8074 – Marjorie Senior Center

BID ADDENDUM NO. 1

DOCUMENT 009113.01 – ADDENDUM 1

- A. Project Name: Marjorie Stewart Senior Center Lobby & Restroom Improvements.
- B. Owner: City of Sherwood.
- C. Owner Project Number: 8071 (CDBG #4228).
- D. Architect: Otak Architects, Inc.
- E. Architect Project Number: 16714.
- F. Date of Addendum: March 22, 2013.

Proposed Restrooms - Electrical

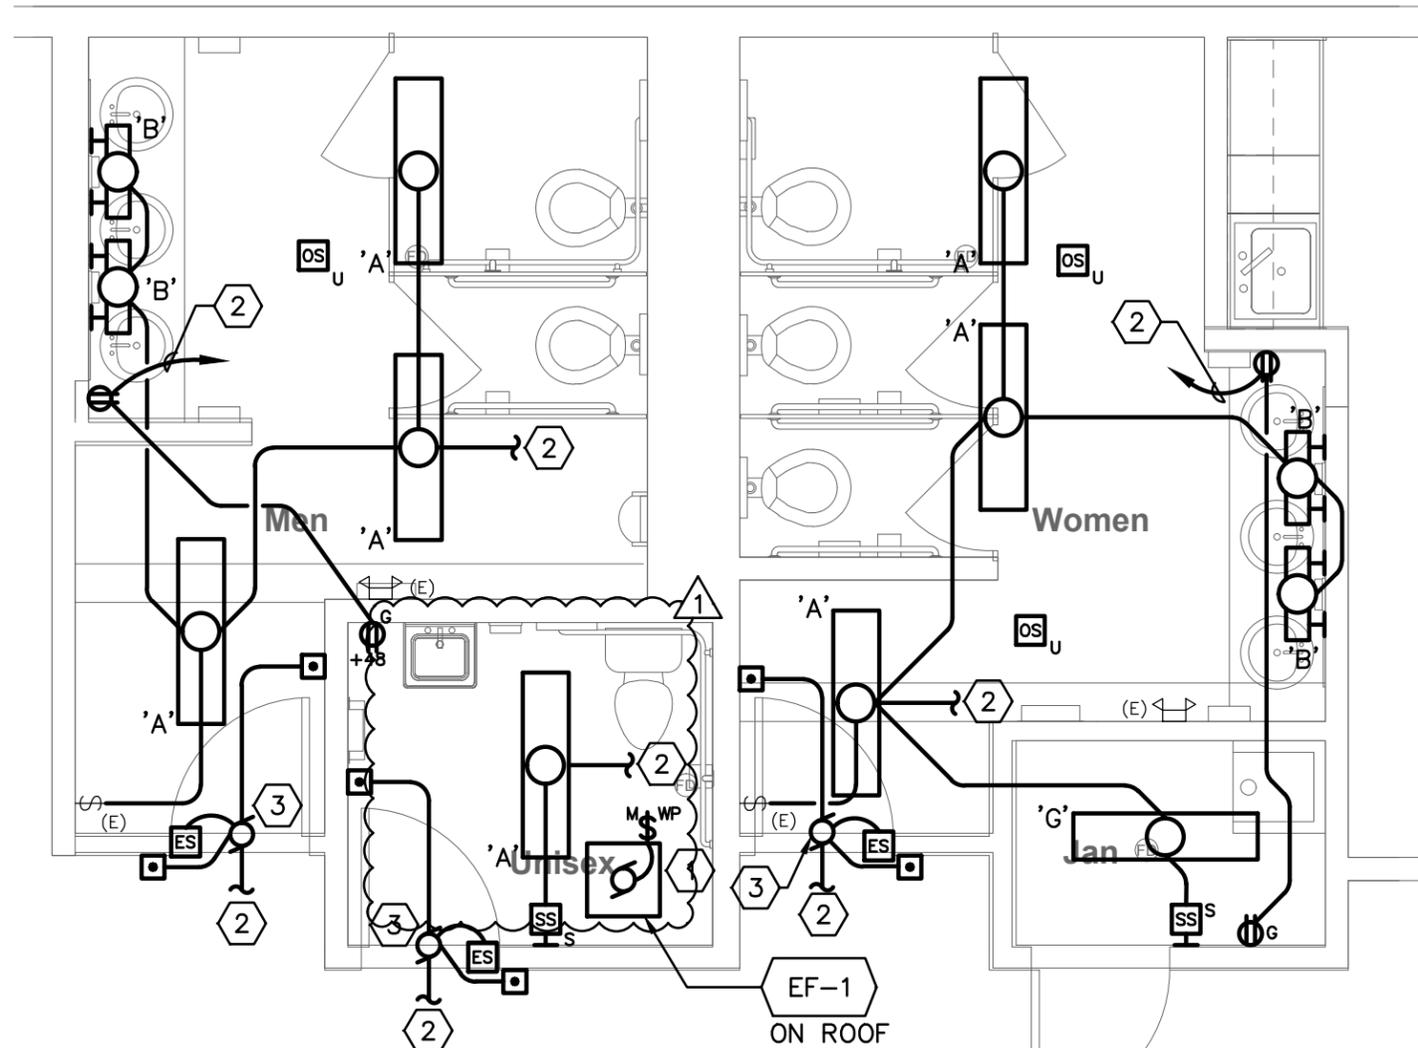
D. Sheet E3.11 – Proposed Restrooms – Electrical (reissued).

1. Replaced above mirror luminaire with Type 'A' luminaire in Unisex restroom.
